UNITED STATES  
DEPARTMENT OF THE INTERIOR  
BUREAU OF LAND MANAGEMENT  
**APPLICATION FOR PERMIT TO DRILL OR REENTER**

| 1a. Type of work: <input checked="" type="checkbox"/> DRILL <input type="checkbox"/> REENTER<br>1b. Type of Well: <input checked="" type="checkbox"/> Oil Well <input type="checkbox"/> Gas Well <input type="checkbox"/> Other<br>1c. Type of Completion: <input type="checkbox"/> Hydraulic Fracturing <input checked="" type="checkbox"/> Single Zone <input type="checkbox"/> Multiple Zone |  | 5. Lease Serial No.<br>NMNM93207<br><br>6. If Indian, Allottee or Tribe Name<br><br>7. If Unit or CA Agreement, Name and No.<br><br>8. Lease Name and Well No.<br>MIDNIGHT HOUR 11 FED COM<br>774H<br><br>9. API Well No.<br>30-015-56448 |

| Property Name and Well Number<br><br><b>MIDNIGHT HOUR 11 FED COM 774H</b> |                                                                                                                |                      |                                            |

## PECOS DISTRICT DRILLING CONDITIONS OF APPROVAL

Proposed Wellbore  
Design A

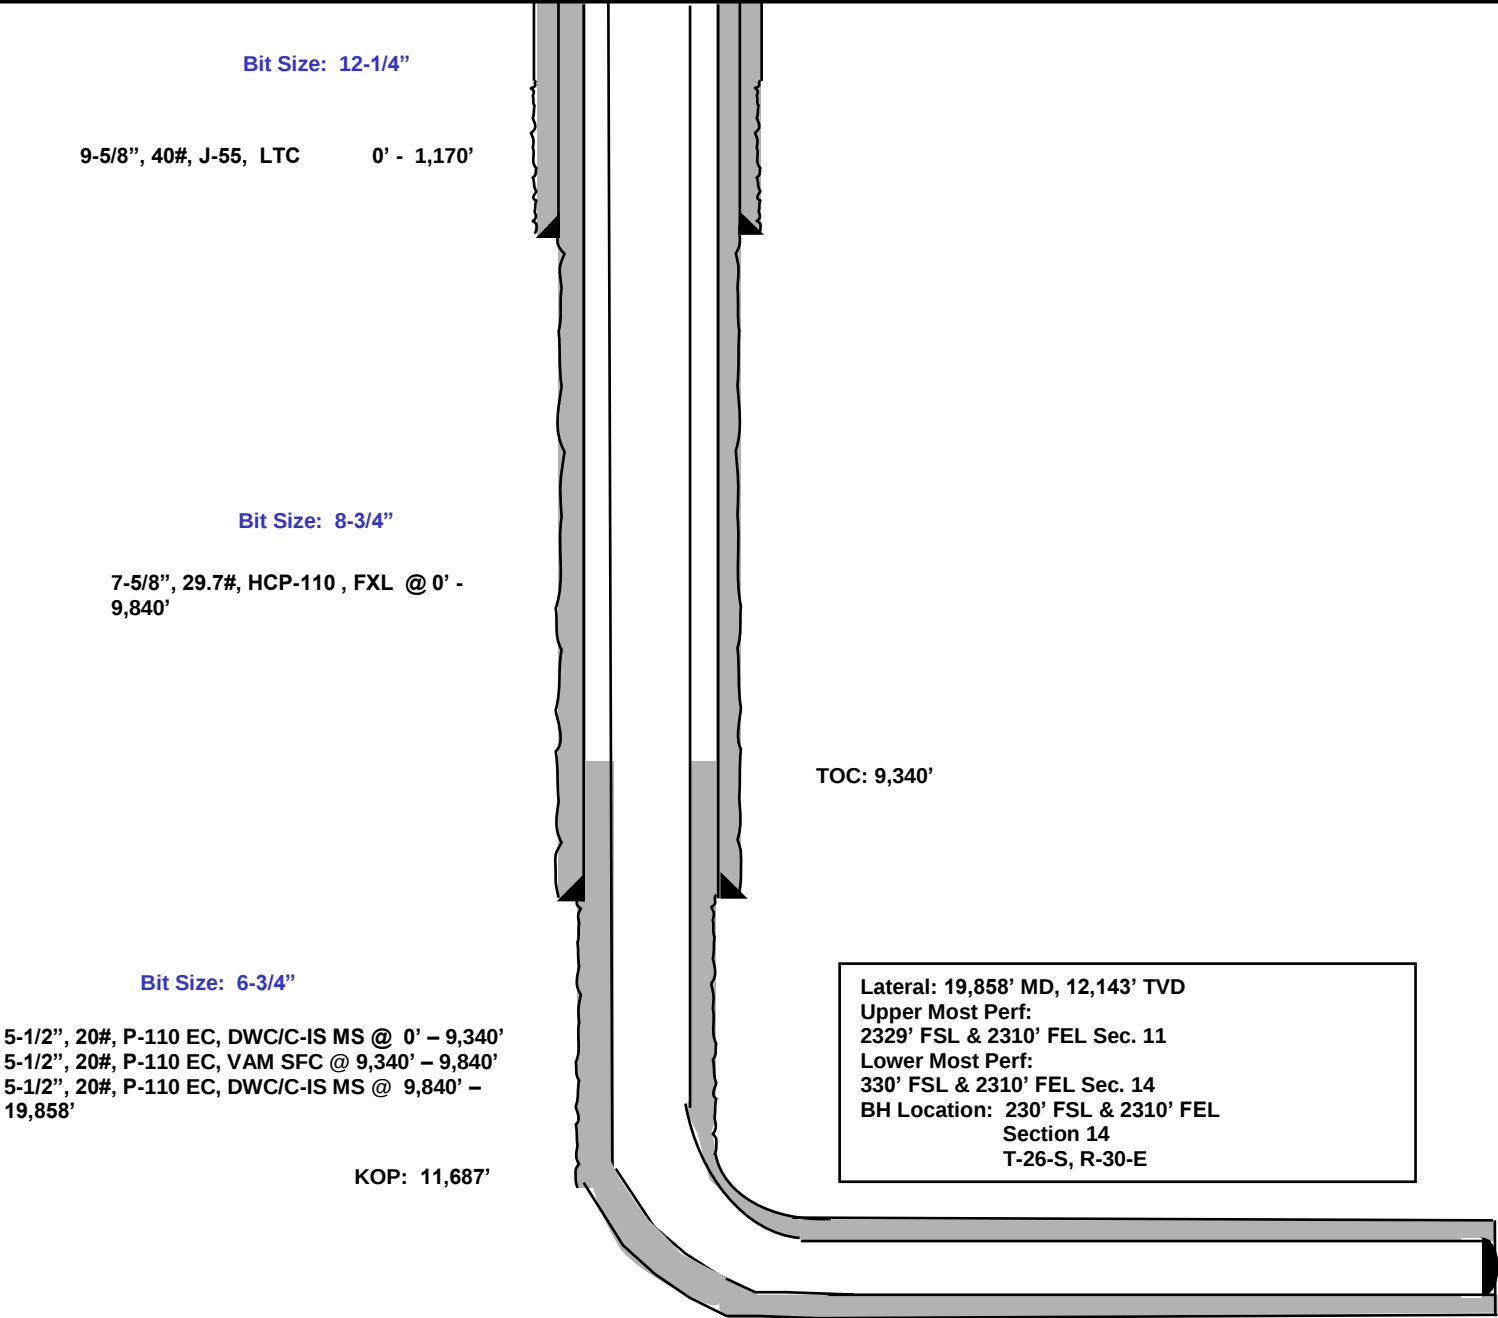
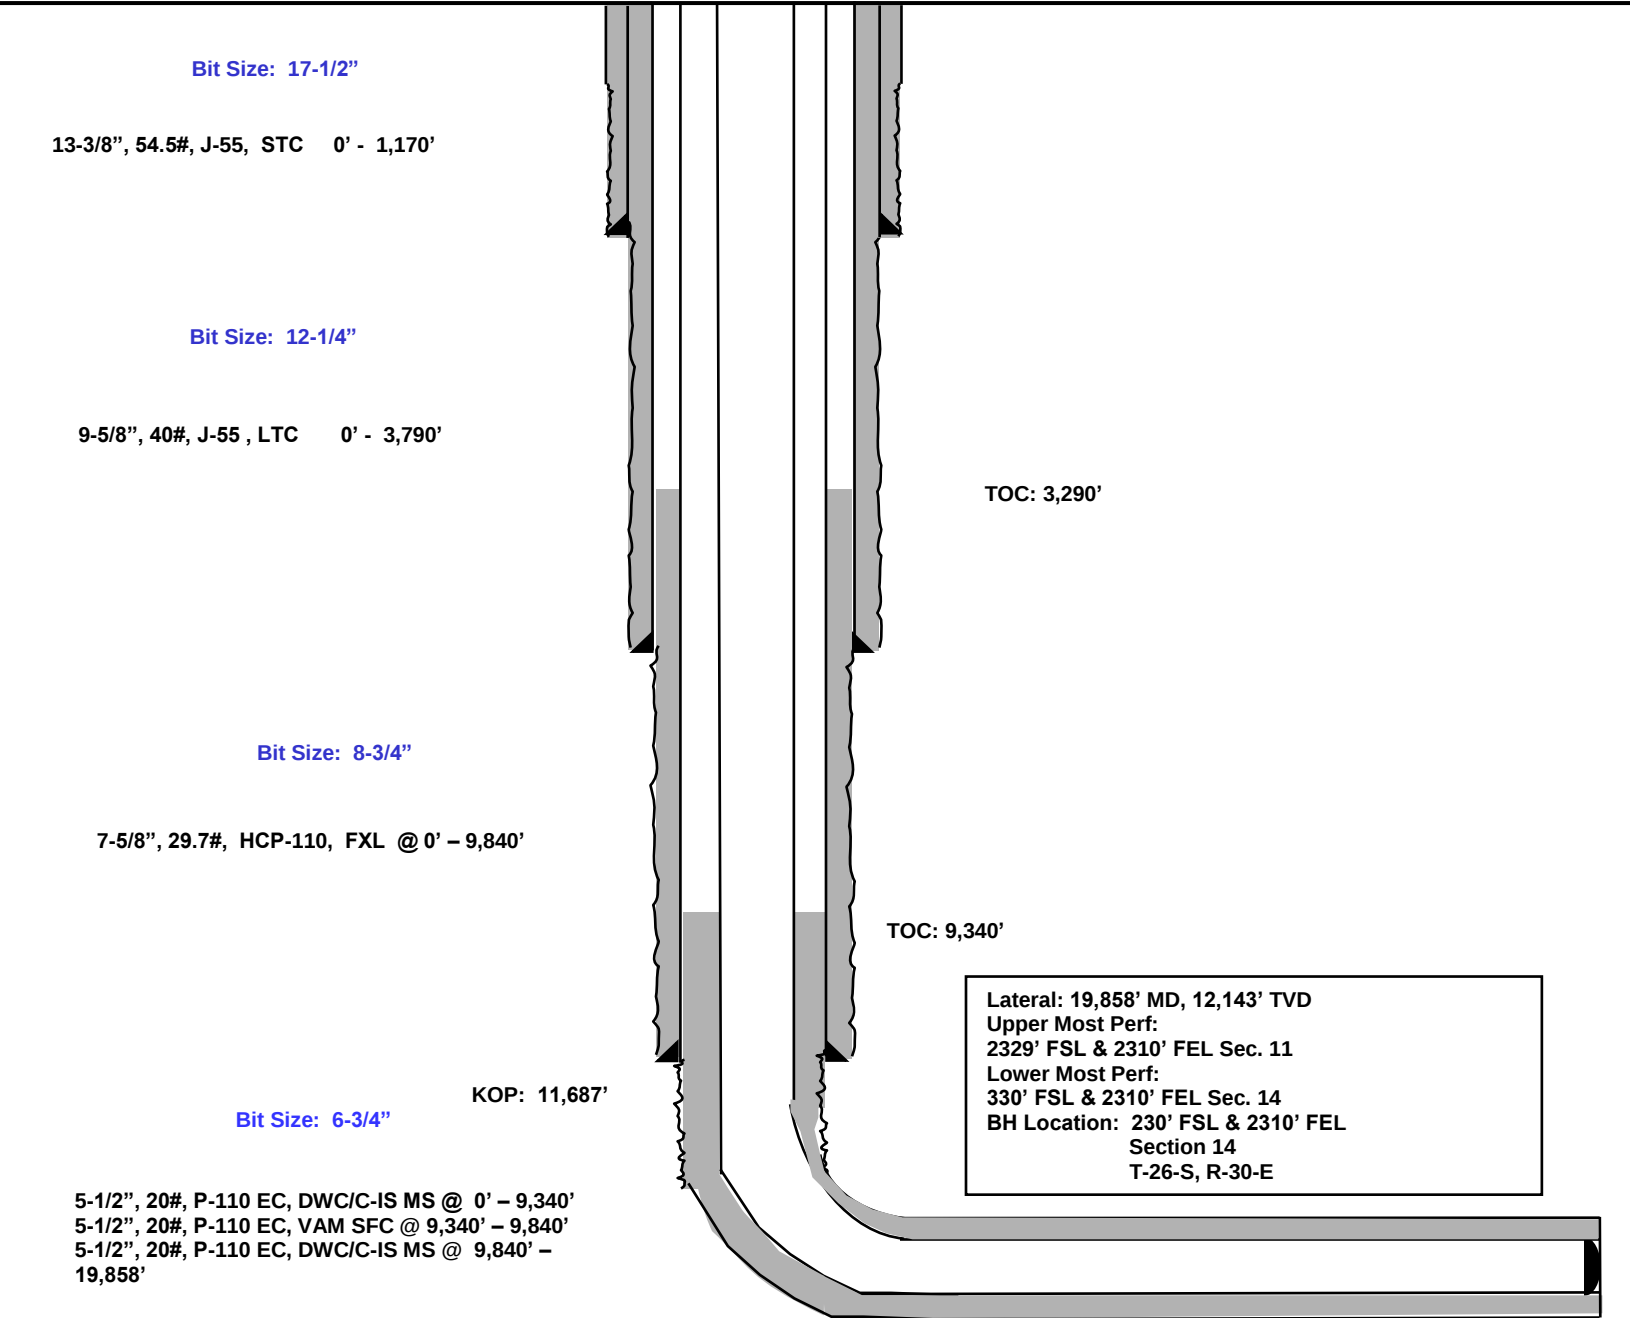
Operator has proposed a primary and alternate casing plan – listed separately below.

**Operator has proposed to pump down 9-5/8" X 7-5/8" annulus after primary cementing stage. Operator must run Echo-meter to verify Cement Slurry/Fluid top in the annulus Or operator shall run a CBL from TD of the 7-5/8" casing to surface after the second stage BH to verify TOC.**

3. The minimum required fill of cement behind the **5-1/2** inch production casing is:
  - Cement should tie-back at least **300 feet** into previous casing string due to operator not meeting casing clearance requirement per OO2. Operator shall provide method of verification.

3. The minimum required fill of cement behind the 7-5/8 inch 2<sup>nd</sup> intermediate casing is:
  - Cement should tie-back at least **300 feet** into previous casing string. Operator shall provide method of verification.

4. The minimum required fill of cement behind the 5-1/2 inch production casing is:
  - Cement should tie-back at least **300 ft** previous casing string due to operator not meeting casing clearance requirement per OO2. Operator shall provide method of verification.
